Office Action Summary

10/532,979

HATORI ET AL.

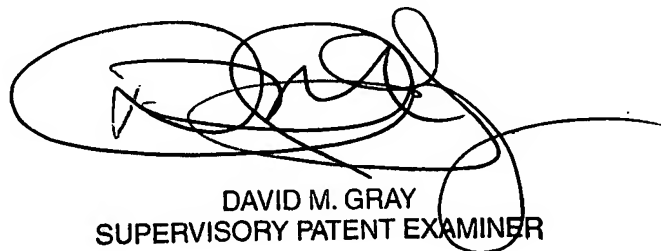
Regarding all other claims, Applicant's arguments have been fully considered but they are not persuasive. The new limitations of claims 1 and 33 do not overcome the prior art of record for at least the reasons stated above in the new citations and the fact that the developing unit can still be replaced into the body of the image forming apparatus through a space (door or etc.) which is different from the one formed by moving the two frames relative to one another.
